GERMAN ADVISORY NOTE

German Advisory Note Number: DE 08

Subject: Lower limit of voltage in DC characteristics

Figure 5: TE voltage/current characteristics

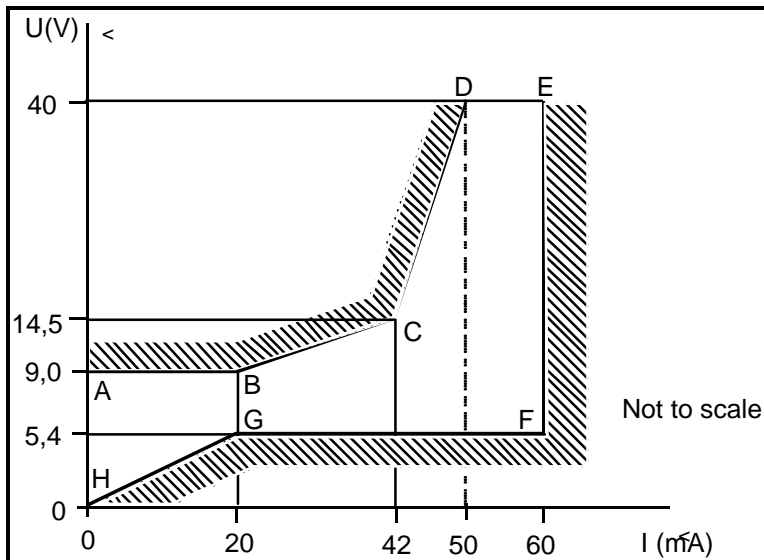
NOTE: The following requirements are in addition to the requirements of CTR 21 Clause 4.7.1 and the associated tests in Clause A.4.7.1. The changes introduced by this Advisory Note replaces the minimum voltage-values of 0 V by 5,4 V at the complete range of more than 20 mA current.

Requirement: The DC voltage/current characteristics of the TE within the operating range as stated in clause 4.7 shall not exceed the limits given in table 5 and shown in figure 5.

Point	Voltage (V)	Current (mA)
A	9,0	0
B	9,0	20,0
C	14,5	42,0
D	40,0	50,0
E	40,0	60,0
F	5,4	60,0
G	5,4	20,0
H	0	0
NOTE:	Limits for intermediate currents can be found by drawing a straight line between the break points on a linear voltage/current scale.
